Attachment 2
WCAP-17065-NP-A
Westinghouse ABWR Subcompartment Analysis Methodology Using GOTHIC
Non-Proprietary Version
U7-C-NINA-NRC-120054

WCAP-17065-NP-A
Revision 0

Westinghouse ABWR Subcompartment Analysis Methodology Using GOTHIC

SUBJECT: FINAL SAFETY EVALUATION FOR SOUTH TEXAS PROJECT WCAP-17065-P,
"WESTINGHOUSE ABWR SUBCOMPARTMENT ANALYSIS USING GOTHIC"

Figure 5-1 GOTHIC Benchmark Noding Diagram

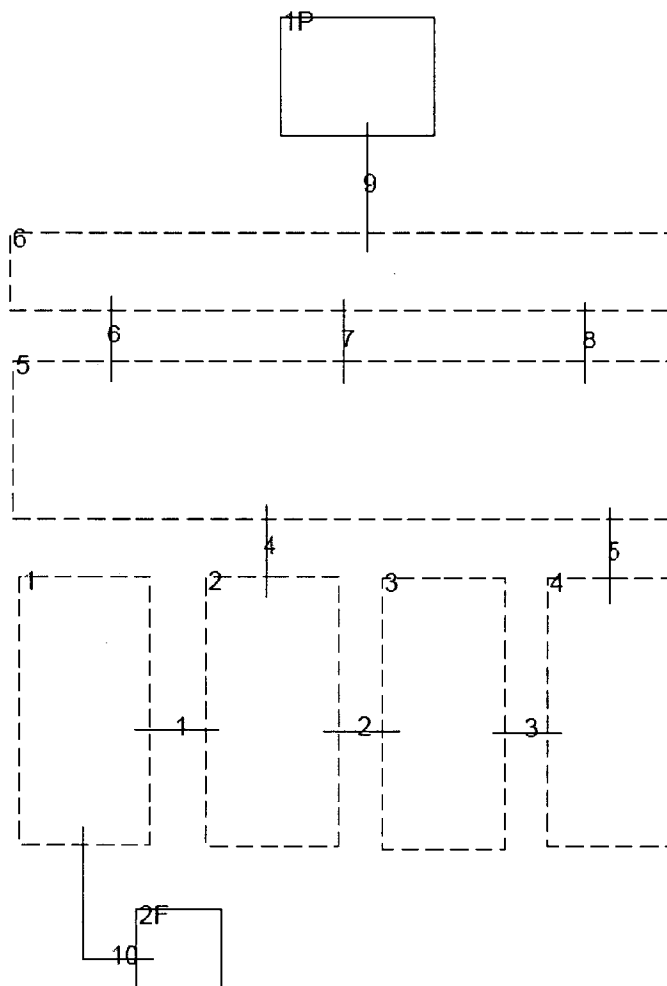
The GOTHIC DCD benchmark model is based on the model provided in the certified ABWR DCD and is composed of six control volumes with two boundary conditions. Figure 5-1 in the topical report displays the node diagram. The benchmark noding consists of the following:

Section 5 of WCAP-17065 presents the GOTHIC benchmark model and results. Figure 5-1 of WCAP-17065 provides the GOTHIC node diagram for the DCD benchmark analyses. This node diagram is based on Figure 6.2-37b of the certified ABWR DCD. The applicant also provided its results from the DCD benchmark models (DCD volume model, [] volume model without additional losses, and [] volume model with additional losses) and compared them to certified ABWR DCD results and TMD results.

The GOTHIC DCD benchmark model is based on the model provided in the certified ABWR DCD and is composed of six control volumes with two boundary conditions. Figure 5-1 in the topical report displays the node diagram. The benchmark nodding consists of the following:

STP clarified that this description was for their proprietary representative model and not the model shown in Figure 5-1. NRC Staff agreed and this was rewritten as follows:

The GOTHIC DCD benchmark model is based on the model provided in the certified ABWR DCD and is composed of six control volumes with two boundary conditions. Figure 5-1 in the topical report displays the node diagram. The benchmark nodding consists of the following:

Figure 5-2 GOTHIC/TMD MSLB Pressure Comparison for DCD Volume Case

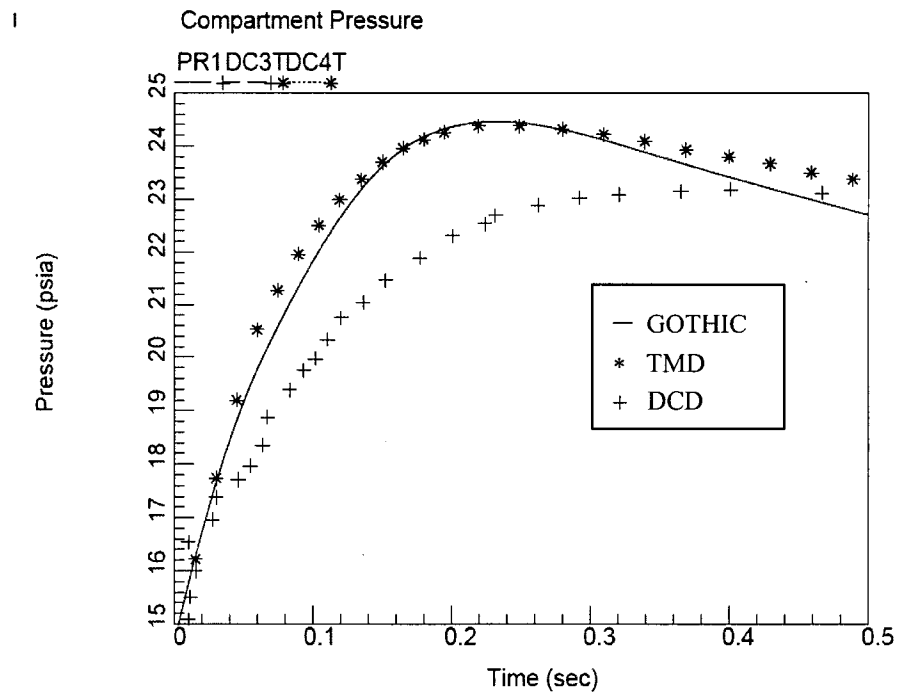
The NRC staff focused its review on the main steamline break (MSLB) results provided in WCAP-17065, Figure 5-2, which compares the results of the DCD volume benchmark model, the TMD, and the certified ABWR DCD. The MSLB is the limiting case for the ABWR DCD subcompartment analysis. Figure 5-2 of WCAP-17065 shows peak pressure results up to 0.5 seconds. The staff noted that the GOTHIC DCD benchmark model provided conservative results with respect to the certified ABWR DCD results in the first 0.5 seconds. The staff asked to review the results in their entirety during the audit on November 9, 2010.

To resolve the differences in the results for the first 0.5 seconds, the NRC staff submitted RAI 7. The staff's confirmatory calculations found that the peak pressure is sensitive to inertia length. By reducing the inertia length, the NRC staff found that the peak pressure could be lowered to better match the results of the DCD. The response to RAI 7 addresses the staff's concern about differences between the GOTHIC DCD benchmark model and the approved results in the certified ABWR DCD, and the NRC staff finds the response to RAI 7 to be acceptable, as mentioned earlier in the report.

The applicant responded in a letter dated January 31, 2011 (ADAMS Accession No. ML1103402764), explaining that it did not have access to the analyses performed by GE; and that the major difference between the analysis the applicant performed and the results given in ABWR DCD Figure 6.2-37m appears to be based on the inertia length used in the analysis. The applicant performed sensitivity studies to confirm its theory and showed that this appeared to be the reason for the major difference in peak pressure.

The NRC staff witnessed sensitivity studies of the inertia length input performed by the applicant at the November 9, 2010, audit. Based on the applicant's response and the NRC staff's confirmatory calculations mentioned above, the staff finds this response to be acceptable and the values used for inertia length in the ABWR DCD benchmark calculation to be conservative.

Figure 6-2 Reactor Building Pressure Response for a MSL HELB in the Reactor Building

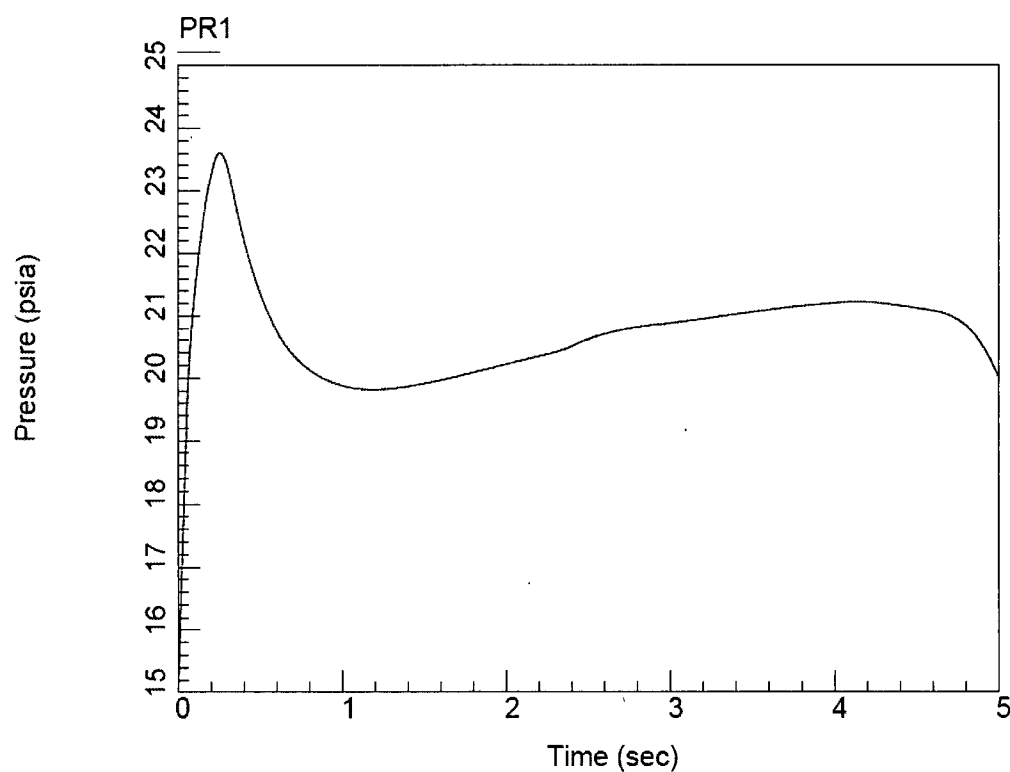
]. Figures 6-2 through 6-5 provide the results for an MSLB and a feedwater line break for the representative steam tunnel model.

The NRC staff performed independent confirmatory analyses using the information provided in Appendix A to WCAP-17065. The NRC staff confirmed that the results of the representative steam tunnel GOTHIC model are conservative. The model employs the subcompartment methodology assumptions described in Section 3.3 of this SE. In RAI 5, the NRC staff also asked the applicant to provide the GOTHIC input deck for further review of the nodalization sensitivity study and pressure transients. In RAI 1, the NRC staff asked the applicant to submit its mass and energy release data used for the analysis to support the staff's confirmatory and sensitivity calculations. The applicant submitted both the GOTHIC input deck and the GOBLIN mass and energy data used for the MSLB in the representative steam tunnel model. The NRC staff was able to confirm that the methodology described above did provide results that were acceptable compared to the NRC staff's confirmatory calculations.

Figure 4-1 GOTHIC Model for BFMC Test D-1

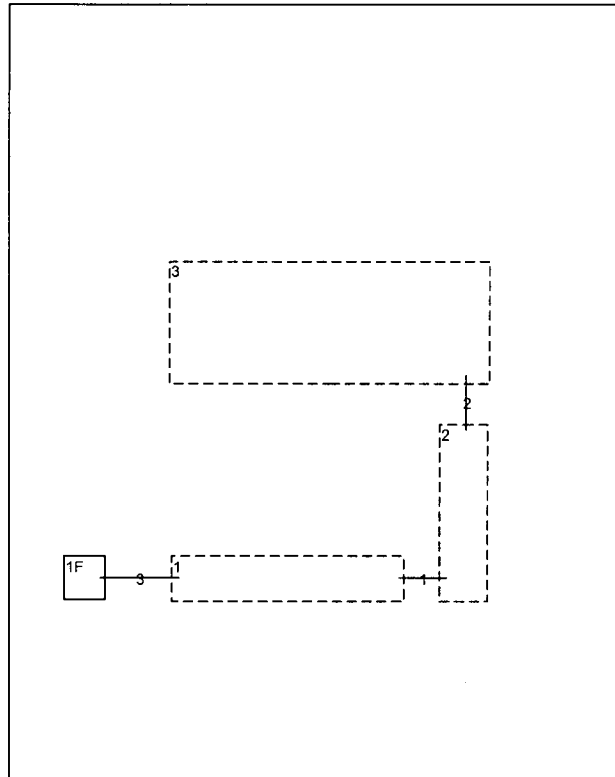
The applicant revised cases from the GOTHIC qualification report for tests D-1, D-15, and D-16 from the Battelle Frankfurt Model Containment and test V21.1 from the Heissdampfreaktor facilities. The results presented for the time-dependent differential pressures in each case compared very well between the Equation 2-2 model and the cell center-to-center model. For most cases, the model using Equation 2-2 was conservative compared to the test data and agreeable to the center-to-center model predictions. For those cases in which data were not bounded, the Equation 2-2 model and the center-to-center model compared very well. The staff found that the comparison to tests D-1 and D-15 best represents the ability of the GOTHIC model using Equation 2-2 to be used for the analyses in WCAP-17065. The results for these two tests offer evidence that Equation 2-2 can provide conservative results in comparison to the test data and agreeable results to inertia lengths calculated using a center-to-center approach. Based on this information, the NRC staff determined that this response is acceptable and that the use of Equation 2-2 in WCAP-17065 is acceptable for subcompartment analyses of STP ABWR Units 3 and 4.

As noted earlier, the inertia lengths for the models in the GOTHIC Qualification Report use the room center-to-center distance. In response to this RAI, several of the models for tests in which room-to-room pressure differentials were measured were revised using inertia lengths from Equation 2-2. Specifically, the models for tests D-1, D-15, and D-16 from the Battelle Frankfurt Model Containment (BFMC) and test V21.1 from the Heissdampfreaktor (HDR) facility were revised. Results from these tests are shown below.

In this model, the break location is room 6 (lumped volume #1). The break flow is all steam and is represented by flow boundary condition 1F and flow path #3. The inertia lengths for flow path #1 and flow path #2 have been re-calculated using Equation 2-2. Table 4-1 shows the “C2C” inertia length (based on center-to-center distance) and the “Equ 2-2” inertia length (based on using Equation 2-2 of WCAP-17065-P) for flow paths #1 and #2.
